WST22/00031 | SF2022/045828

SSD-10096818: Buronga Landfill Expansion

TfNSW have reviewed the submitted Traffic Impact Assessment (TIA) and the supporting EIS.

Figure 8.2: Rural basic left-turn treatment (BAL)

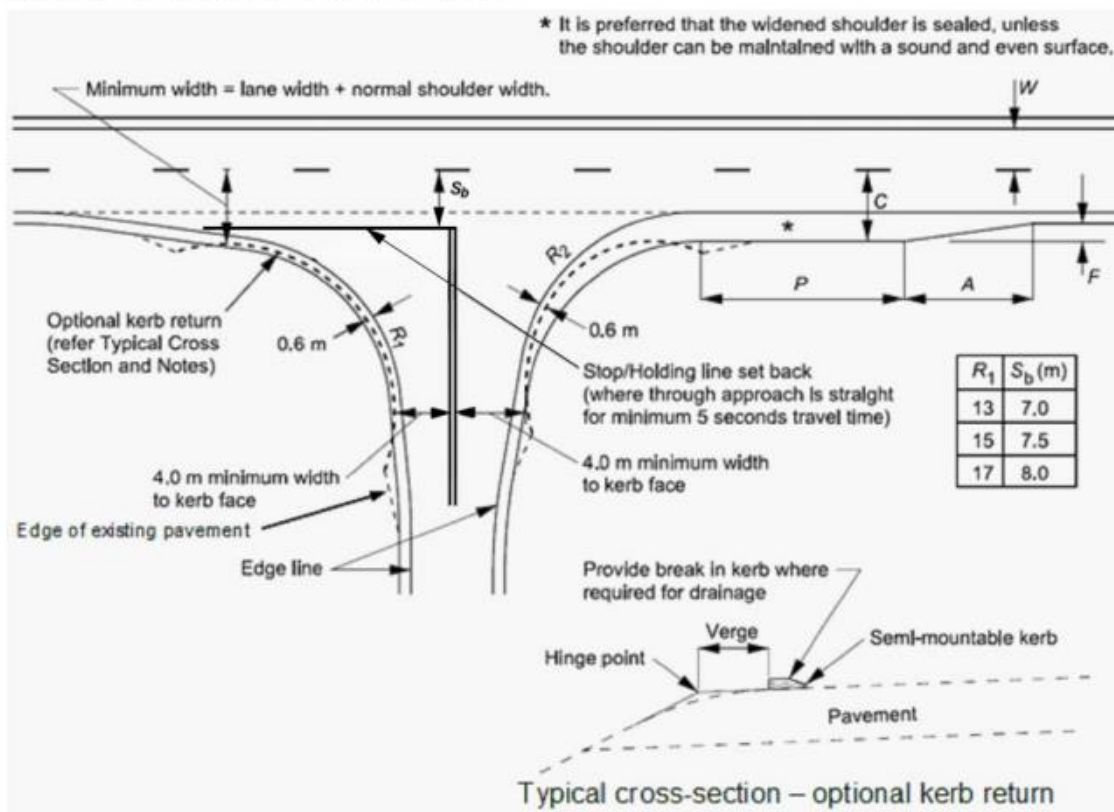
- A Rural Basic Left (BAL see figure 8.2 within Attachment 1) and a Rural Basic Right (BAR see figure A6 with Attachment 2) turn treatments are required to be constructed at the intersection of Arumpo Road and the site access prior to the commencement of construction works associated with this project. The intersection treatments are to be designed in accordance with *Austroads Guide to Road Design*.
